**CGS Comments on Hollywood Center Project DEIR FINAL 20200716.pdf**
2459K

July 16, 2020

SUBJECT: Comments on the April 16, 2020 Draft Environmental Impact Report for proposed "Hollywood Center" project. State Clearinghouse Number SCH 2018051002.

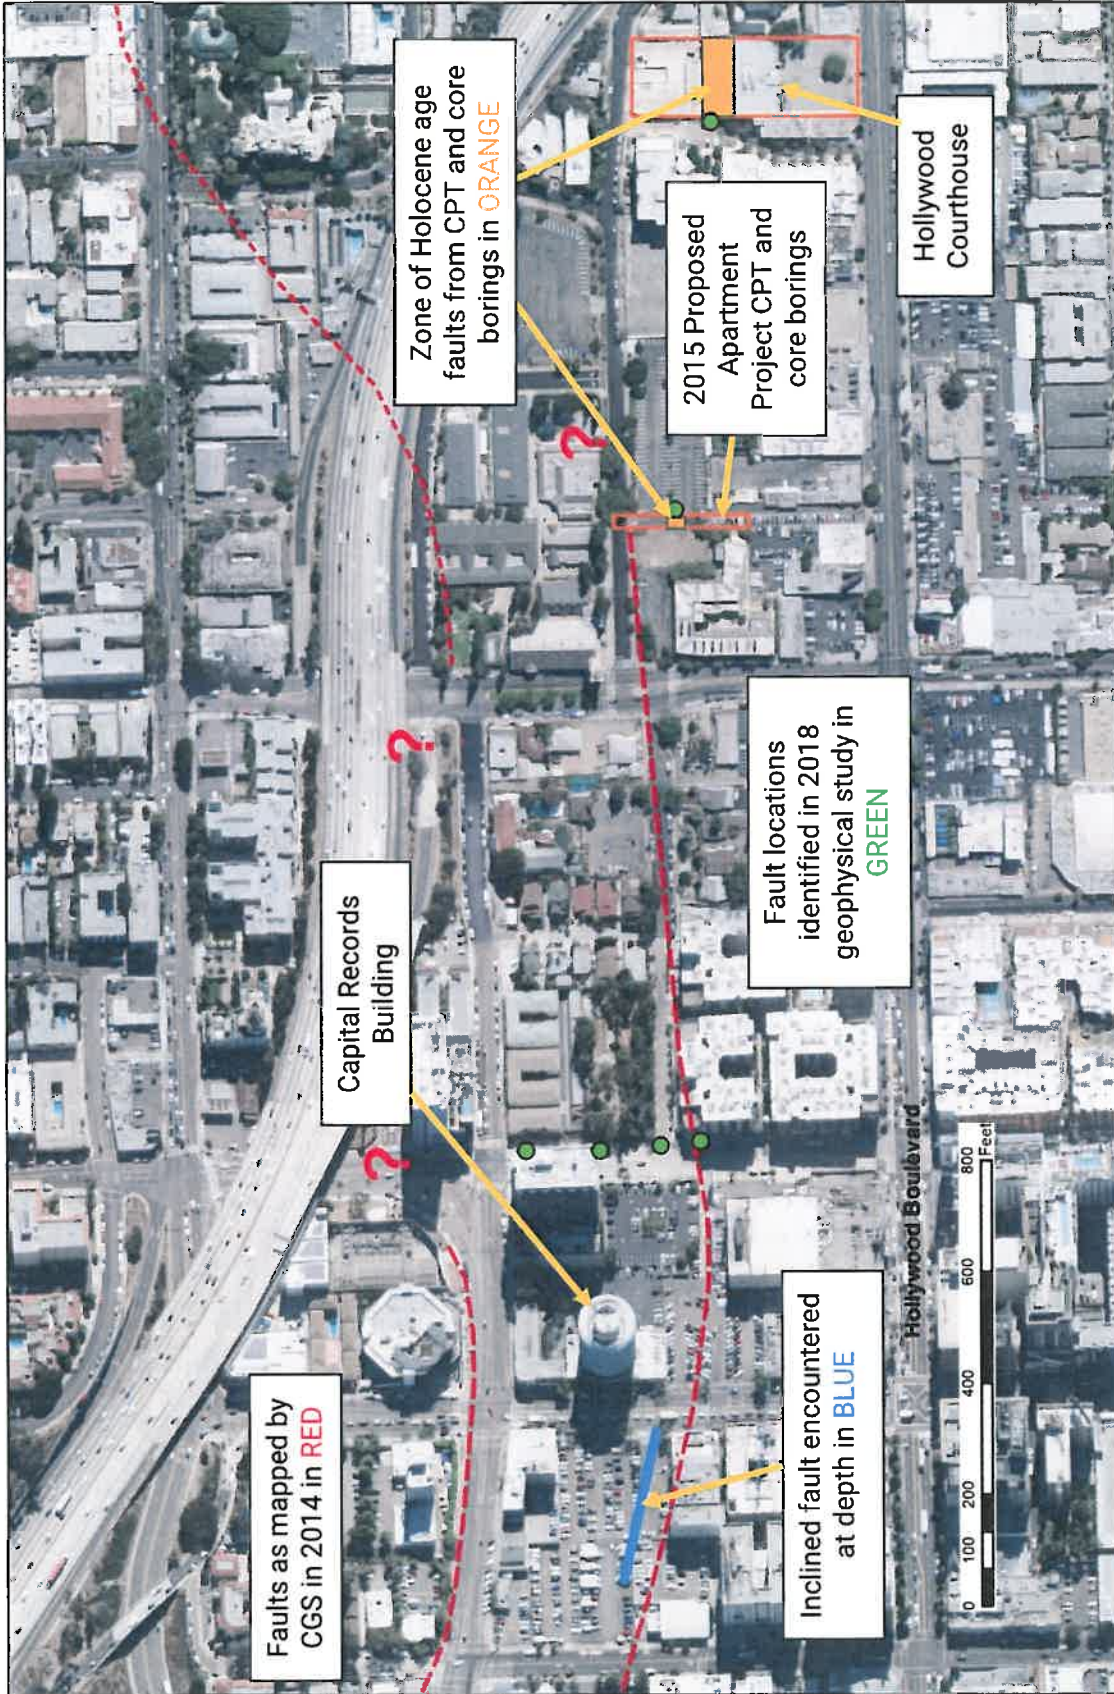
1. **Fault traces depicted in CGS's 2014 Hollywood Fault Map do not appear in Appendix G-1's figures of the project site** where locations of their subsurface investigations are presented. Therefore, we attach a figure showing both the location of traces as shown on the 2014 Hollywood Fault Map and the areas of investigation reported in Appendix G-1 (**Figure 1**). (DEIR Appendix G-2 shows the location of the fault trace at a lower level of resolution.) We note below that Figure 1 reflects new information indicating the active fault, which was not cleared by either the 2014 trench or the other investigative techniques reflected in Appendix G-1.

2. **The 2020 USGS study, and other studies that post-date CGS's 2014 Hollywood Fault Map, strongly suggest an active strand of the fault crosses the project site.** CGS considered the 2020 USGS study in light of other studies conducted after the 2014 Hollywood Fault Map. These studies are listed at the end of this letter and, for your convenience, are also available on CGS' FTP server ([FTP Link](#)). These studies, conducted east of the project site, postdate the studies included as Appendix G-1 to the DEIR, and are therefore new information of importance to public safety. These studies strongly support the presence of an active southern fault strand entering the eastern Hollywood Center property in the vicinity of the alley at Argyle, south of the

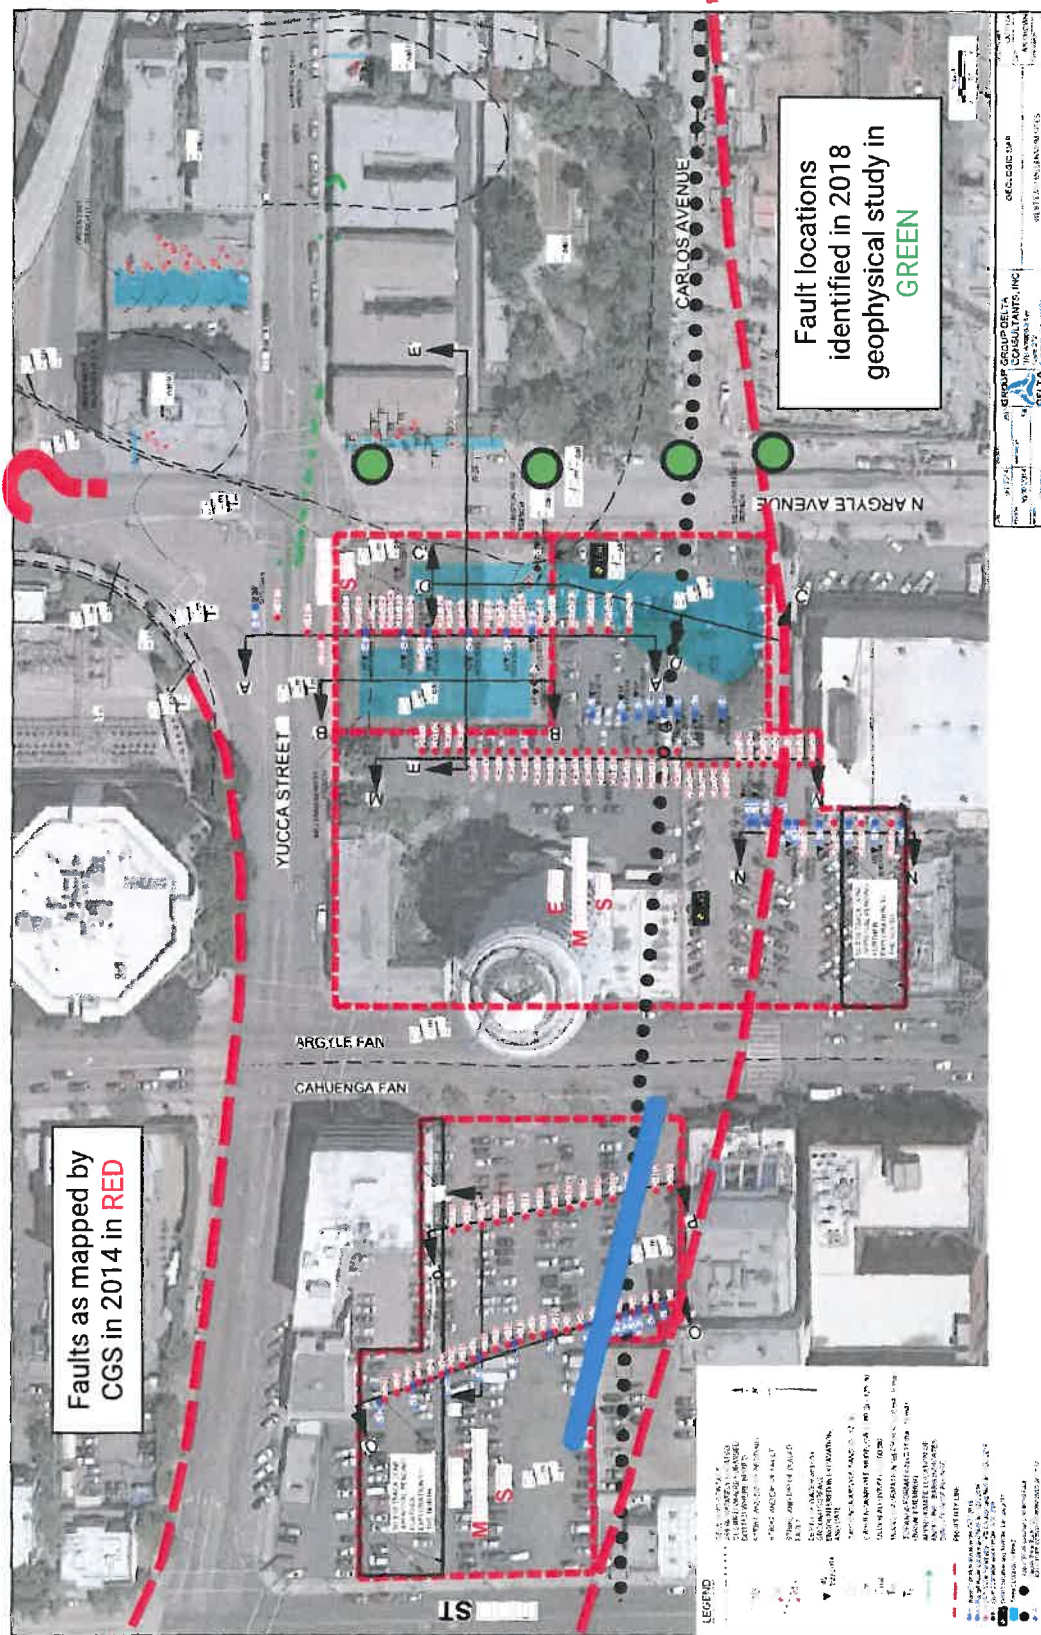
3. **The fault trench excavated in 2014 did not clear the entire site of active faults.** Based upon review of the information presented in Appendix G-1 of the DEIR, the GDC trench on the east property did not completely expose the base of the Holocene-age geologic section across the north-south extent of the site and therefore cannot be considered to exclude the presence of an active fault at or near where it is depicted in CGS's 2014 Hollywood Fault Map, or in the more recent studies mentioned above.

4. **Other fault investigation techniques used on the site are not definitive in clearing the site of active faults.** Based on review of the information presented in Appendix G-1 of the DEIR, the fault studies prepared for the proposed Hollywood Center Project, both east and west properties, primarily rely upon subsurface investigations conducted by Cone Penetration Testing (CPT) and small-diameter boreholes. While these types of investigations can provide beneficial information, they are subject to ambiguous interpretations, particularly regarding the activity of faulting because geologists cannot clearly see which stratigraphic horizons are cut by a fault. A third-party review of the geologic studies conducted for the Hollywood Center Project (see Earth Consultants International, Project No. 3425, June 3, 2015; [FTP Link](#)), which was not included in Appendix G-1 of the DEIR, acknowledges the limitations of the project CPT and borehole subsurface investigations, including unresolvable errors in the re-survey efforts of these data locations. The third-party review also presents multiple possible interpretations of the locations and activity of the faults under the site (ECI, 2015, Plate 4), including an interpretation showing the distinct possibility that the southern strand of the Hollywood Fault is active beneath the project site (ECI, 2015, Plate 4, Interpretation A). CGS understands the project proponents report the project site is underlain by older stratigraphy, capped by Holocene age deposits (<11,700 years old). In their interpretation of boreholes and CPT's, they have postulated the faulting they have identified does not extend into the Holocene units. CGS' interpretation of the CPT and borehole data finds the fault can be drawn to extend into the Holocene units, such as Scenario A in the ECI report. These differing interpretations of fault activity along the southern strand are because only
